Comparison Report

OLD ：3FM00300823

NEW : 3FM00300824

This noncritical component change has been evaluated by DIVA; the initial successor evaluation showed the new successor is compatible with former model. None of the other components and program will be needed to recalibrate or implement. The ECN will be provided if you approve.

Package Dimension

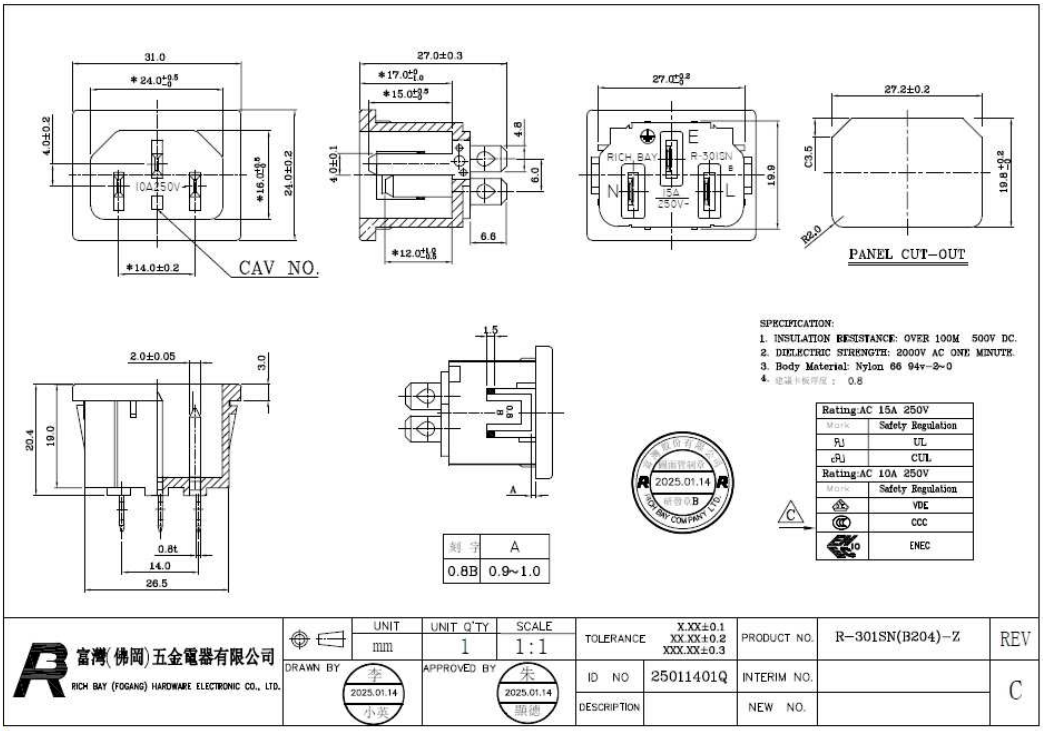
AC SOCKET (R-301SN(B00)-Z,RICH BAY)

AC SOCKET (R-301SN(B204)-Z,RICH BAY)

OLD ：3KH0007734B

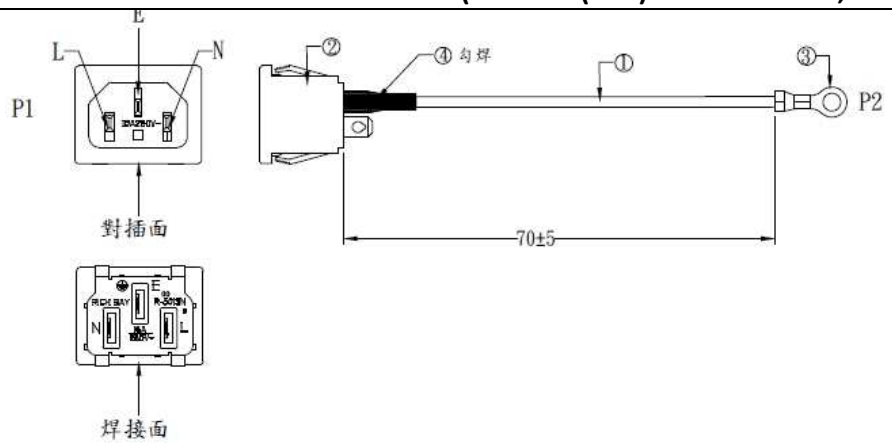
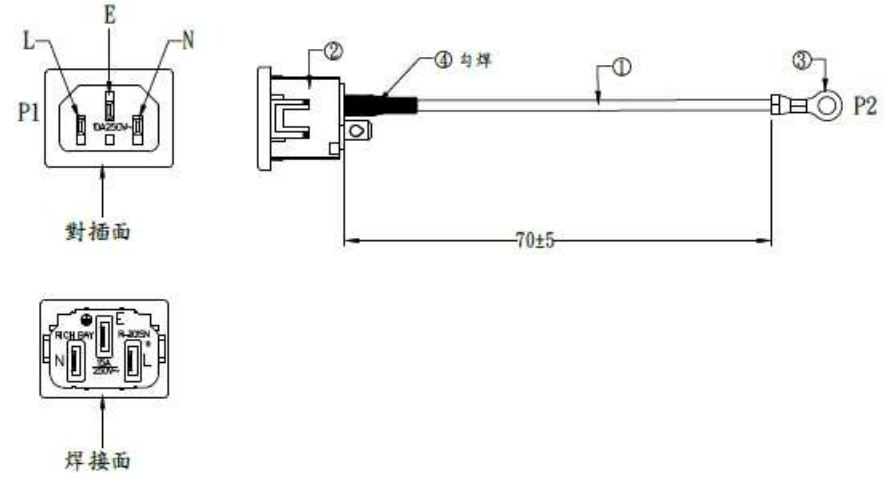
AC SOCKET(R-301SN(B00)-Z &GND WIRE,YOMIN

AC SOCKET(R-301SN(B204)-Z&GND WIRE,YOMIN

項目	材料名稱	用量
1	WIRE:UL1015#18 -LF- (REI HSING) 顏色：黃/綠	L=79mm 1PCS
2	電源插座：富灣 R-301SN(B204)-Z 臺北購買	1PCS
3	TERMINAL:WST-B40405BS-2 限用	1PCS
4	HEAT SHRINK TUBE:BLACK 5.0Φ L=15±2mm 厚	1PCS

PICTURES

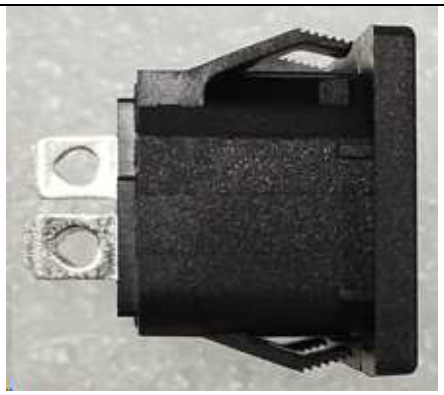
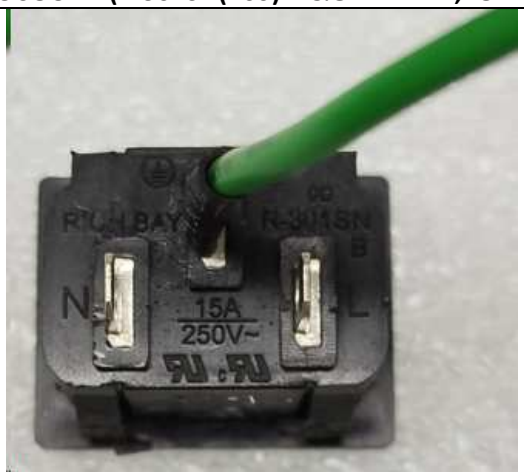
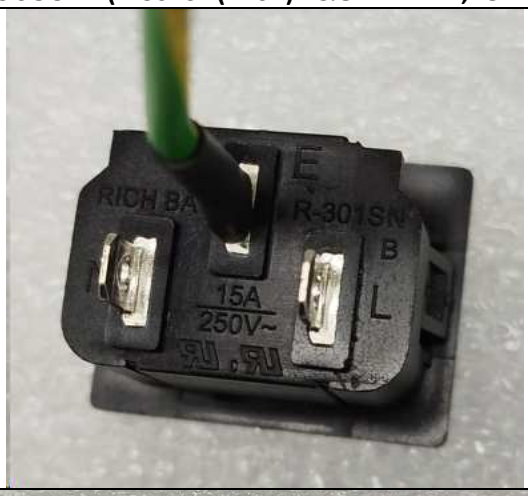
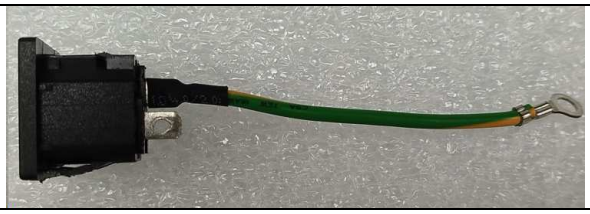
Item	OLD : 3FM00300823 AC SOCKET (R-301SN(B00)-Z,RICH BAY)	NEW : 3FM00300824 AC SOCKET (R-301SN(B204)-Z,RICH BAY)
Front View		
Top View		
Side View		
Back View

Item	OLD ：3KH0007734B AC SOCKET(R-301SN(B00)-Z &GND WIRE,YOMIN	NEW ：3KH0007734C AC SOCKET(R-301SN(B204)-Z&GND WIRE,YOMIN
Back View		
Side View
